Re: Starcraft RV, Inc. - Bed Bracket Recall

**Safety Defect and Noncompliance Report Guide for Vehicle
PART 573 Defect and Noncompliance Report¹**

VIN Range for Bed Bracket Recall - Starcraft RV, Inc.

LOCATION OF
TAPE AND HOLD DOWN

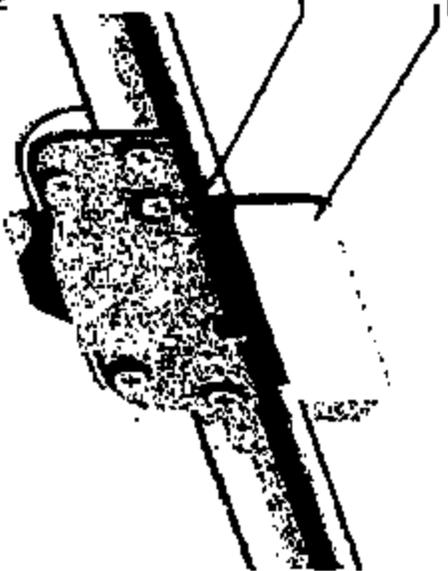
Modified size and strength of support bracket to allow use of more fasteners per bracket. See attached drawing.

Two-hole aluminum bracket (old) vs. six-hole aluminum bracket (new).

PLASTIC SUPPORT
HOLD DOWN PLATE
CENTERED OVER BRACKET,
FRONT AND SIDE BED DECKS
TOP BRACKET RANGES UP AGAINST
BOTTOM SIDE OF RIBBLE.

1. REMOVE THE OLD BRACKET, BECAUSE ANY PLASTIC HELD DOWN TAPE REMAINS FROM THE OLD BRACKET. BEYOND THE POINTS WHERE THE BRACKET IS ATTACHED TO THE SHEA BED.
2. LOCATE THE NEW BRACKET BY THE TOP RANGE OF THE BRACKET UP AGAINST THE TOP EDGE OF THE JOINTS. SET TWO NEW BRACKET SUPPORT BRACKET HOLES TO THE LEFT OF THE HOLES OF THE OLD BRACKET. OFFSET THE BRACKET FROM THE ORIGINAL POSITION TO INITIAL BUT MARK.
3. MAKE ALL SPACES FOR PER-DRILLING.
4. DRILL THE TOP HOLES WITH A 1/4" DIA. DR. DRILL ONLY THROUGH THE ALUMINUM EXTRUSION AND THE SURFACE OF THE RIBBLE.
5. DRILL THE LOWER 2 HOLES WITH A 3/8" DIA. DR. DRILL. DRILL ONLY THROUGH THE RIBBLE AND THE BED DECK.
6. PLACE NUTS, SCREWS ON BACK SIDE OF THE UPPER TWO HOLES OF THE NEW SUPPORT BRACKET (P/A), AND THE BACK SIDE OF THE SHEA BED.

2. MARK THE INITIAL BRACKET WITH 9/16" X 1 1/2" FLAT HEAD SCREWS IN THE TOP HOLES, AND 21/16" X 1 1/2" FLAT HEAD SCREWS IN THE BOTTOM HOLES.

4. DRILL AND RE-DRILL, INITIAL BRACKET WITH 9/16" X 1 1/2" FLAT HEAD SCREWS IN THE TOP HOLES, AND 21/16" X 1 1/2" FLAT HEAD SCREWS IN THE BOTTOM HOLES.

5. THE LOWER ALUMINUM RANGE OF THE BED BY CIRCUMFERENTIAL SURFACE WITH A SQUARE OF ROUNDTOP ALCOXIL (P/N: E029 0061) AND WATER ALLOY TO SET.

10. WILL THE LOWER END OF THE RIBBLE OF PERMANENT HOLD DOWN PLATE (P/C) BE CENTERED TO THE RIBBLE OF THE BRACKET. CENTER THE HOLD DOWN PLATE OVER THE BRACKET AND ON THE BOTTOM RANGE OF THE BED AS SHOWN ABOVE.
